# Technical Service BULLETIN

**M.I.L. "ON" DTC P0420**

**'02 – '04 Camry (2AZ-FE) (Non PZEV)**

ENGINE  
REVISÉD  
EG024-04

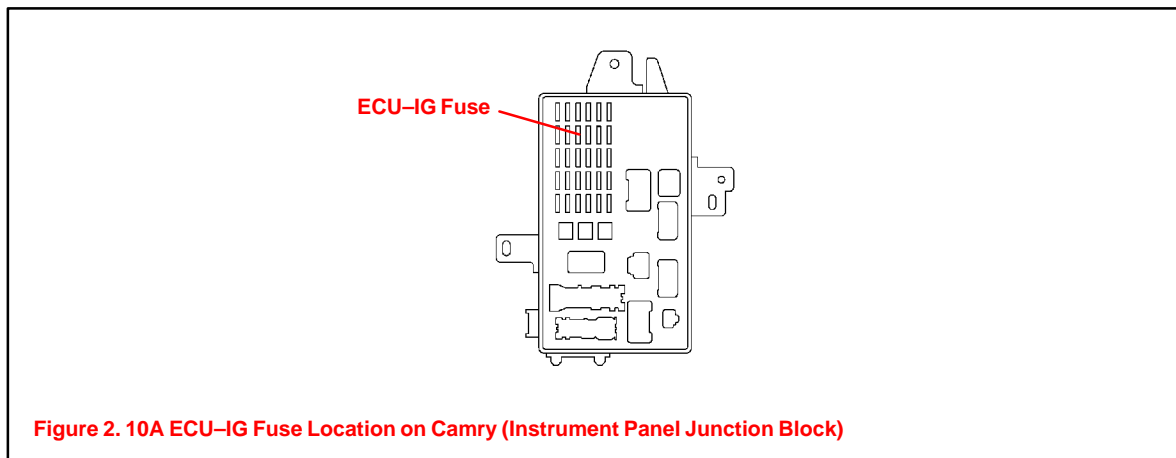
3. Remove the 10A ECU-IG fuse from the instrument panel Junction Block (refer to Figure 2 for location). This action prevents possible activation of the ABS relay, resulting in ECM Reprogramming failure.

**Figure 3. Location of Authorized Modifications Label on Camry**

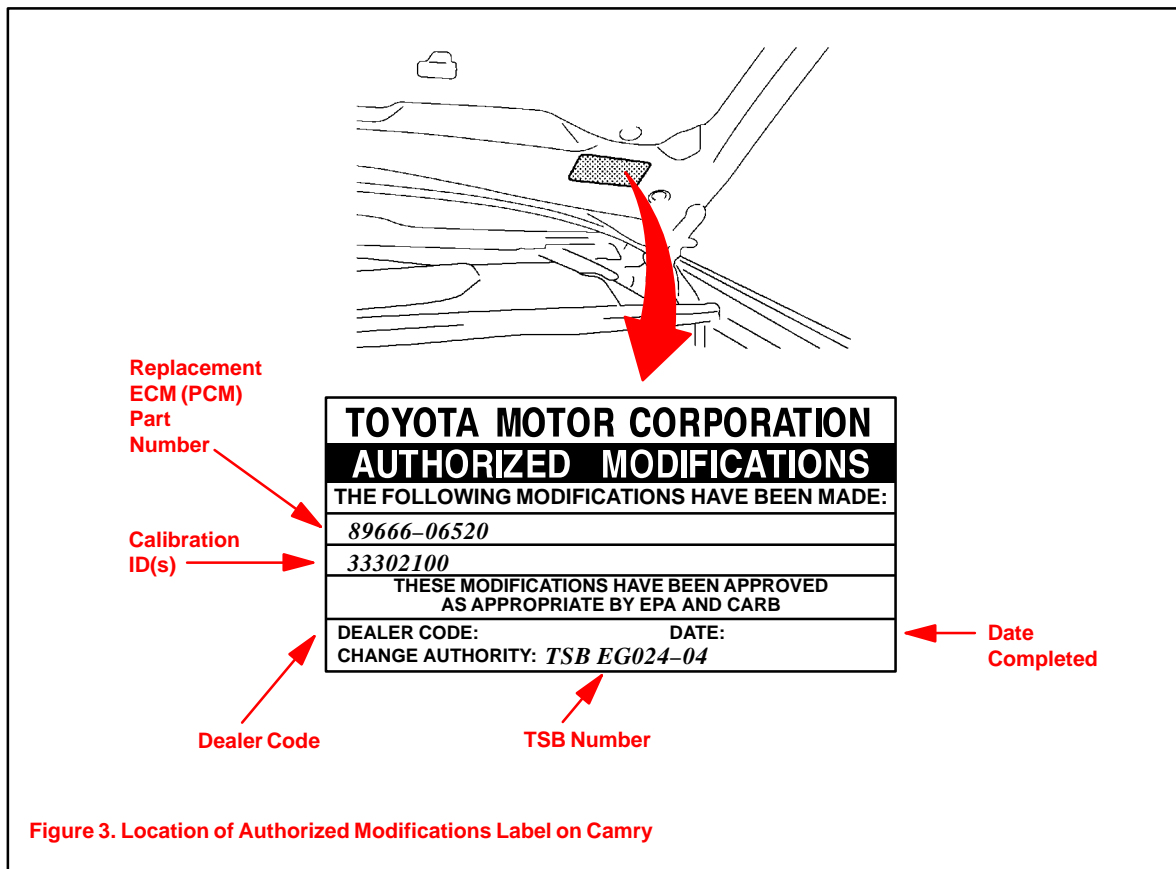
1. Check for the Authorized Modification Label affixed to the vehicle in the location shown in Figure 3. If there is no label present, proceed to step 2.
2. Connect the Diagnostic Tester to the vehicle and select "CURRENT ECU CAL" from the "ECU REPROGRAM MAIN MENU." To determine the vehicle's current ECM (PCM) calibration, see Figure 1 below.
